NOTICE OF NSA DECISION

Case File: T2-2021-14521
Permit: Geologic Hazards
Applicant: Terra Lingley,
Oregon Department of Transportation
Owner(s): Union Pacific Railroad
Company
Location: Located within the right-of-way along E. Historic Columbia River Highway between
Milepost 17 and 18.

Proposal Summary: Request a Geologic Hazards permit for the repair and maintenance of two viaducts and
multiple retaining walls that support the East Historic Columbia River Highway. The
project is located on both sides of Multnomah Falls between Milepost 17 and 18.

Decision: **Approved with Conditions**

EROSION CONTROL PLAN

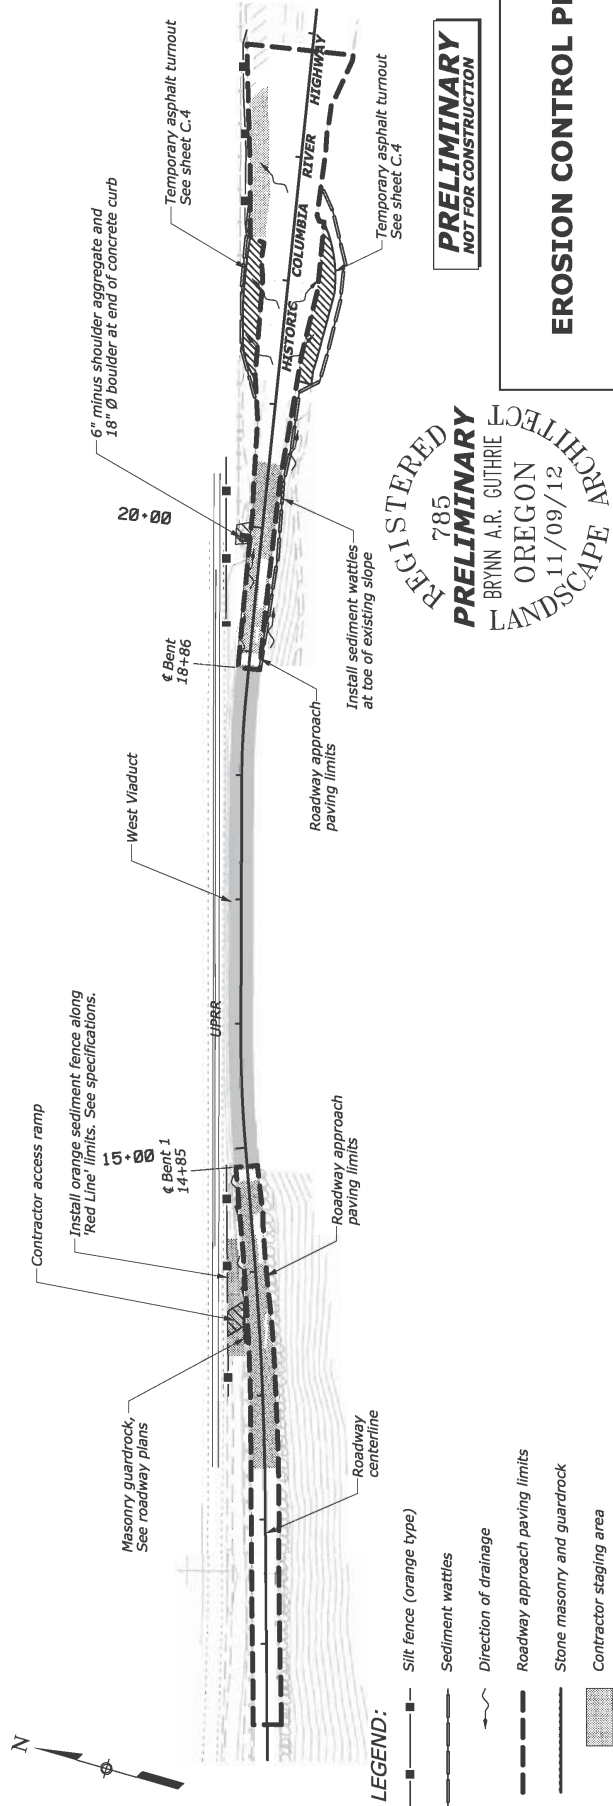
Staff: The Erosion Control plan shown in Exhibit A.11: E1-4 indicates that the project area will be located between the public road and the railroad tracks. There is one area in the project, which is located near a waterbody. That waterbody, Benson Lake is located on the opposite

side of the railroad tracks, 30 feet from the project boundary. The applicant's erosion control plan was designed as their mitigation plan. The ground disturbance is not permitted to encroach on the Union Pacific Railroad, which is 10 feet from the outer extent of the project boundary. North of the railroad there is a buffer of natural vegetation that will also not be disturbed (Exhibit A.11: Sheet E.1-4). *This criterion is met.*
